RANDAL PARK PHASES 2-5 PLAT

Request for Major Subdivision Plat to create the preliminary plat for Randal Park Phases 2-5.

Updated: March 28, 2013

PRELIMINARY PLAT—PHASE 3

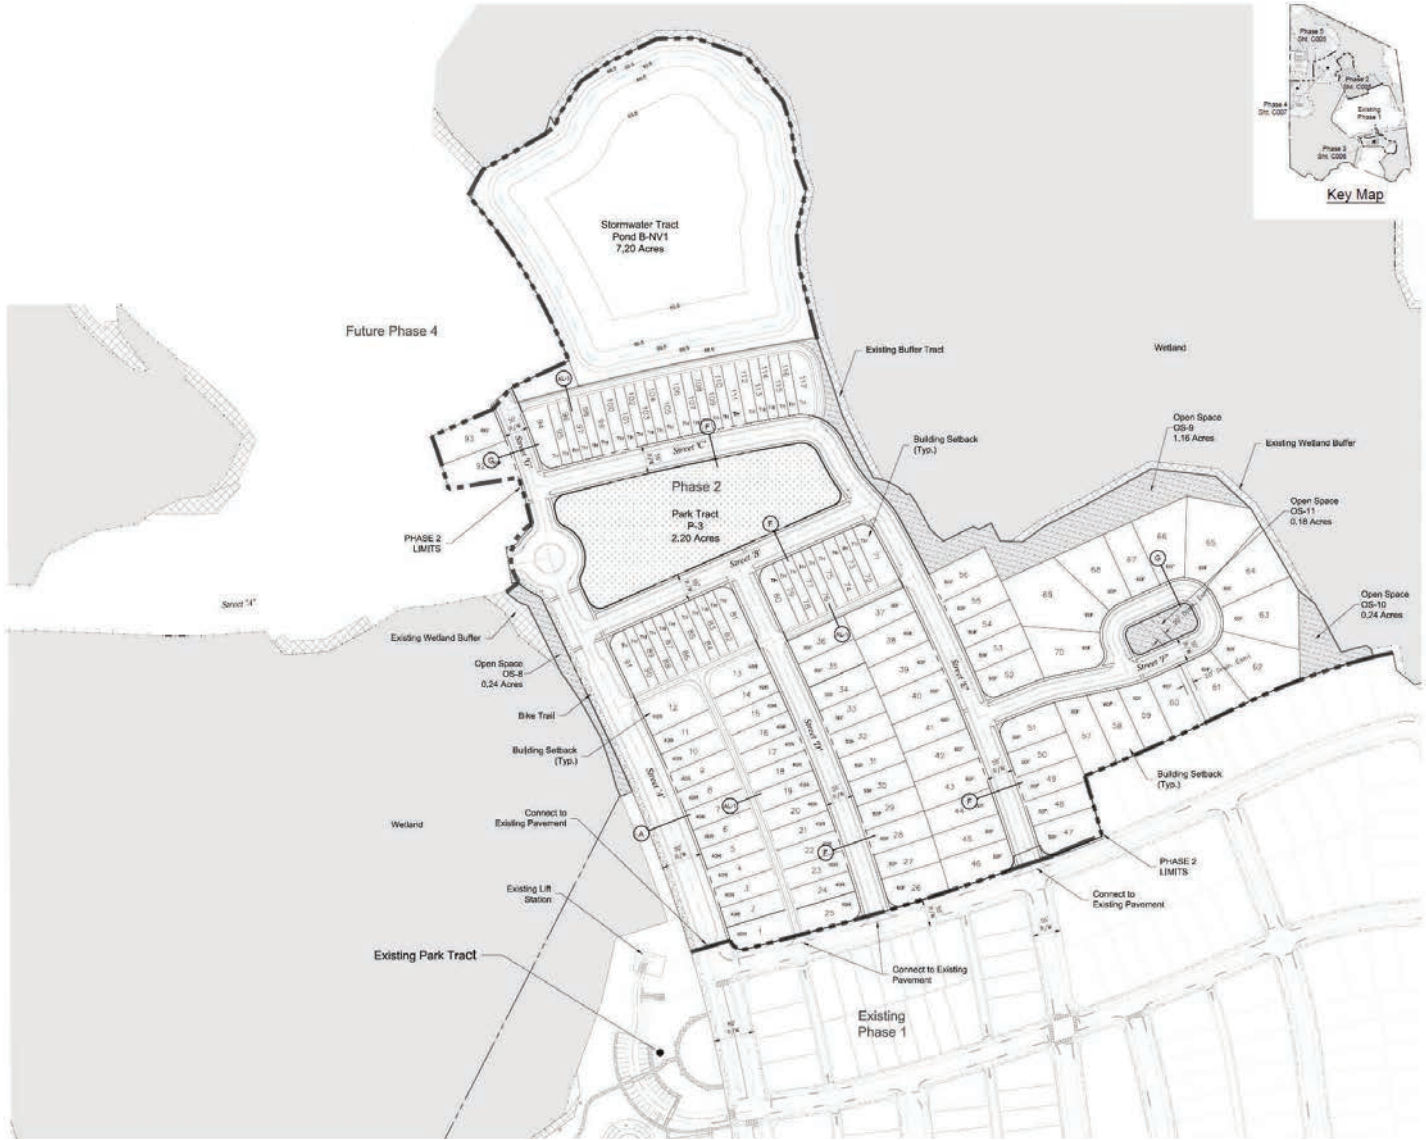
- The roadway and sewer in the southern most phase (shown as Phase 3), is under construction. Sanitary sewer main stubouts to serve Phase 3 have been installed as part of the sewer main construction to serve the school. Individual laterals will not be allowed to be cut in to the newly constructed sewer. Sanitary sewer service to Phase 3 shall be coordinated with the infrastructure currently under construction known as Randal Park Phase 3, case no. ENG2012-00937.

TYPICAL ROAD CROSS SECTIONS

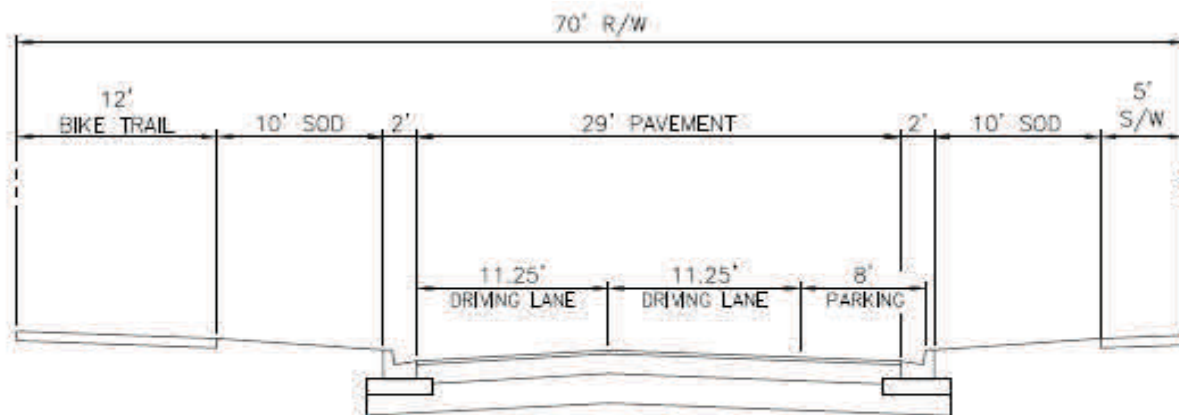
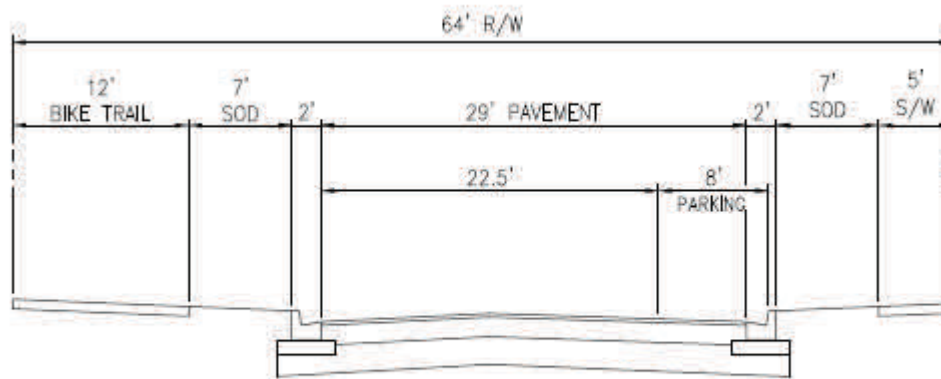
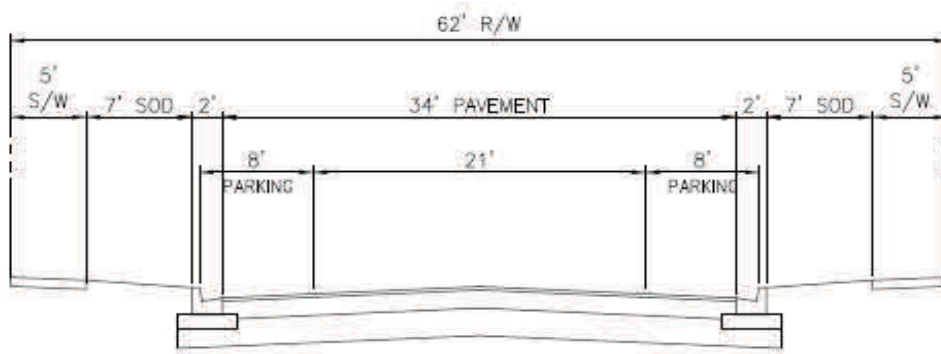
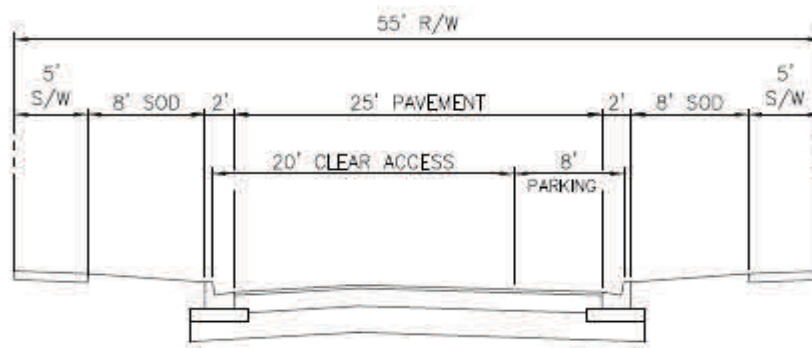
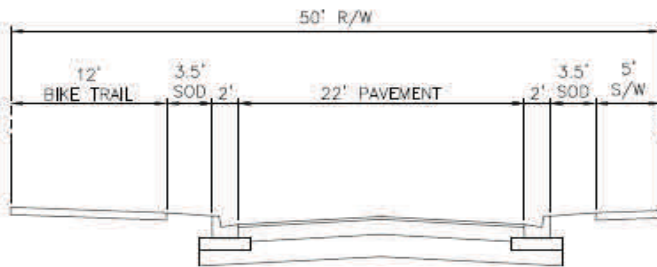
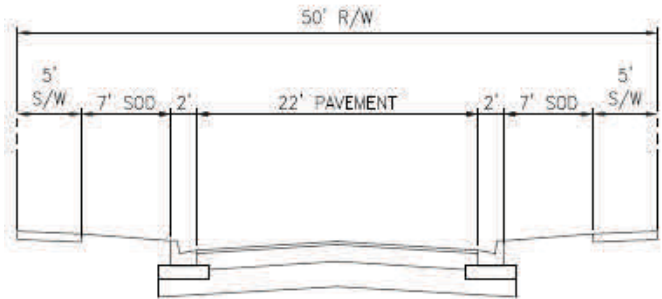
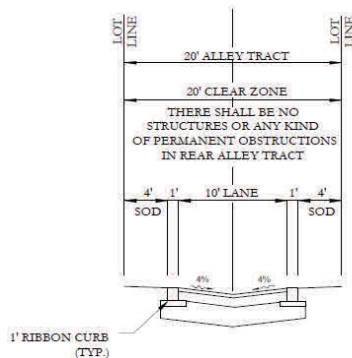
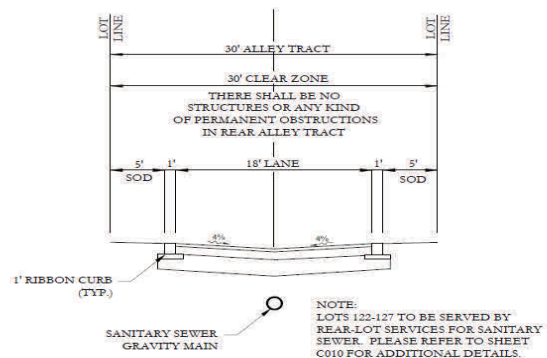
Transportation. According to the Randal Park PD, Section 3 provides guidelines for transportation needs. The applicant has submitted typical road cross-sections for its Neighborhood Streets and Alleys. The roadway cross-sections, which are found on page 12 and 13 of this report, shows a variety of sections which meet or exceed the PD requirements of 7 foot wide parkways, 5 foot side-walks, 8 foot wide on-street parking spaces, and 20 foot dedicated two-way alley tracts. There are two different alley types of cross sections. There is a one-way alley cross-section which has a 20 foot right-of-way a 10 foot travel lane and 4 foot landscaping buffers. The other one-way alley cross-section has a 30 foot right-of-way with an 18 foot travel lane and 5 foot landscaping buffers.
